OFFICE VISIT FROM: Personnel from Dick X-Ray Company
and Designs for Tomorrow, Inc.

Re: Source capsules - Commando Schalt to teletherapy unit

In compliance with your request there are enclosed three copies of our drawing #1950, setting forth details of the fabrication of the capsule (source link) to be employed with the Commando Schalt teletherapy unit.

TITLE	COPPER PLUG	
REVISIONS	DATE	BY
1. REPLACE SCREEN-PLUG WITH PRESS-FIT PLUG	6-1-60	
DATE	7-1-60	
TYPE	TYPE 40 - 100000	
FIGURE	FIGURE 1

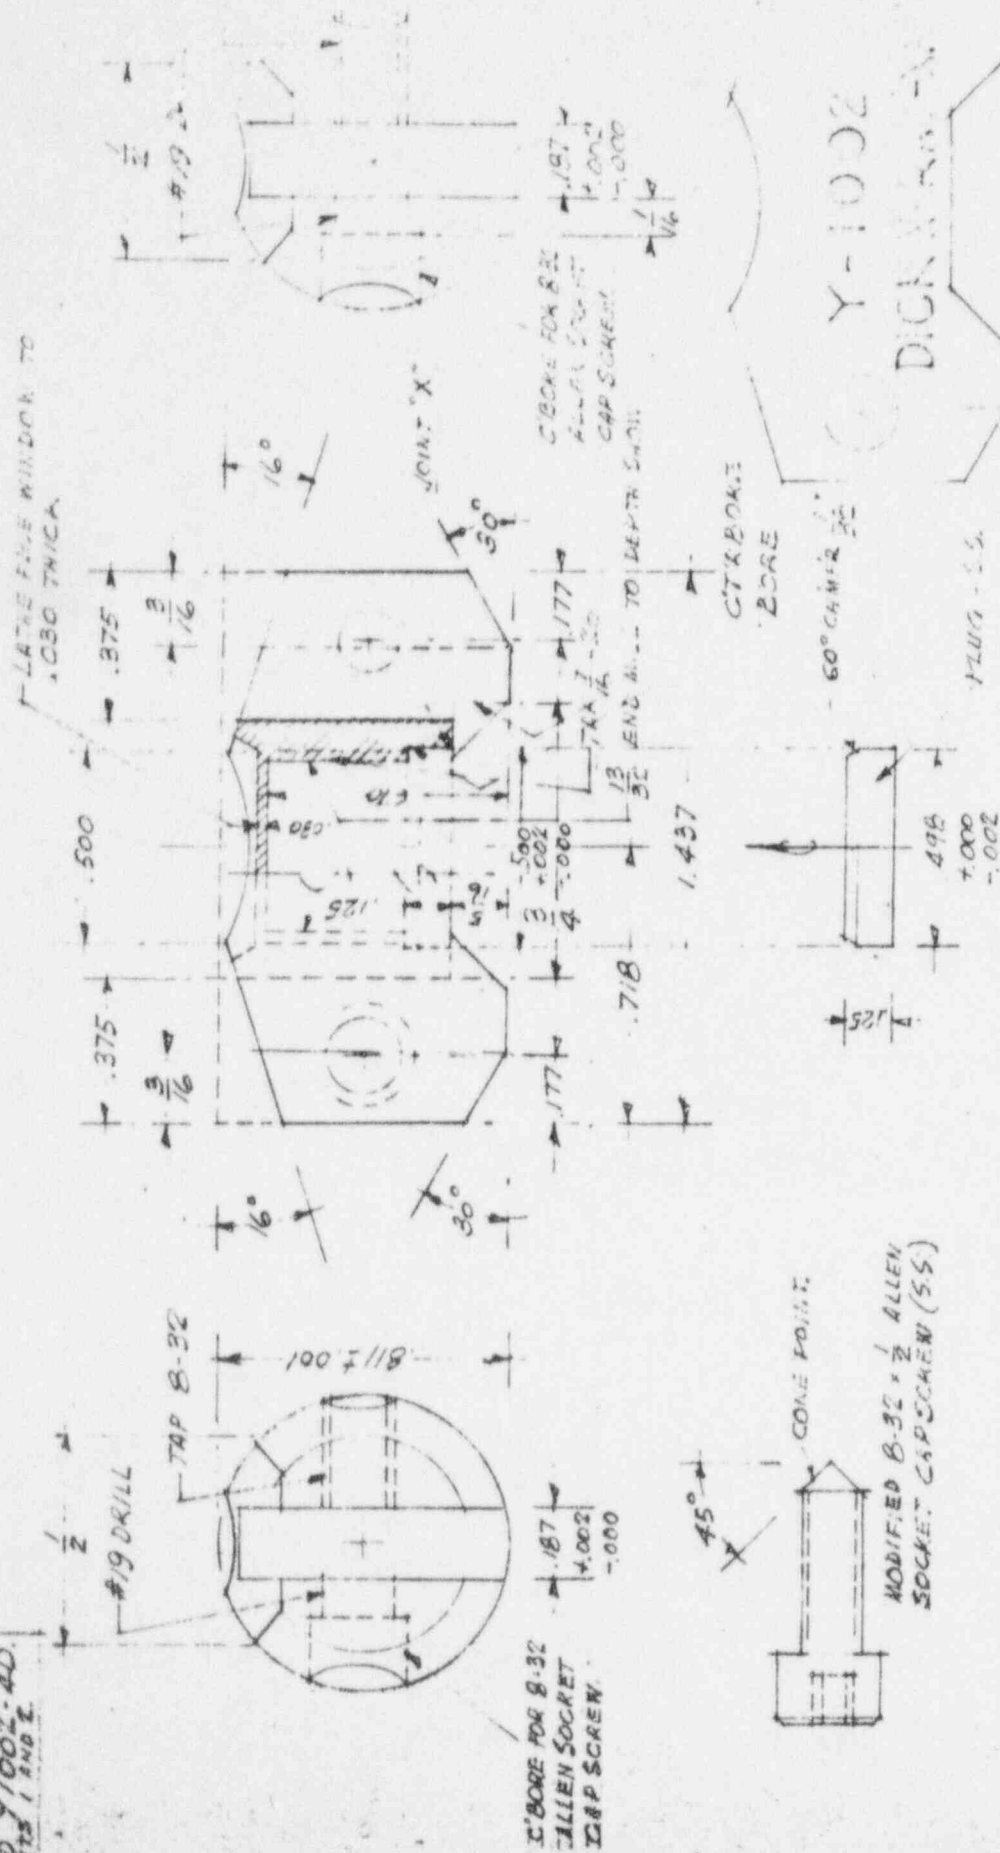
On May 4th this year, we wrote you requesting approval of certain modifications in the fabrication of the capsule (source link) to be employed with the Commando Cobalt 60 Teletherapy unit. Your reply dated May 12th, with the subject reference, granted permission to employ the modified capsule with units then constructed and in inventory.

Subsequent to this correspondence, we were advised by the Instruments Division of The Budd Company who load our capsules, that they had adopted a policy of sealing all capsules loaded by them with a Heliarc weld. They further advised that the configuration of our capsule body and the screw plug provided for its closure prohibited reliable welding with the special welding equipment which they had acquired for this purpose.

As a result, they requested certain tentative modifications in the capsule which they believed would enable them to make a satisfactory welded seal. Since that time we have provided them several capsules for trial welds. Based on these trial welds certain detailed changes in the fabrication of our capsule (source link) as originally set forth on our drawing no. 1950, copies of which accompanied our letter of May 4th, have been agreed upon. These changes have been incorporated in drawing #1950 as a revision. Three copies of the revised drawing are enclosed.

Essentially, a revision involves a substitution of a 1/8" thick stainless steel plug which is a press fit in the body of the capsule to replace the screw plug originally employed. This plug is sealed in place by Heliarc welding of the exposed joint between the plug and the body of the capsule after the plug is pressed home. The use of a press fit for this closure as well as the use of the Heliarc method of welding is in

It is our understanding that the source capsule will be sealed by
a Helarc weld in lieu of the previously proposed solder seal.
Since this change appears to decrease the possibility of leakage
from the capsule, it is acceptable to this office.
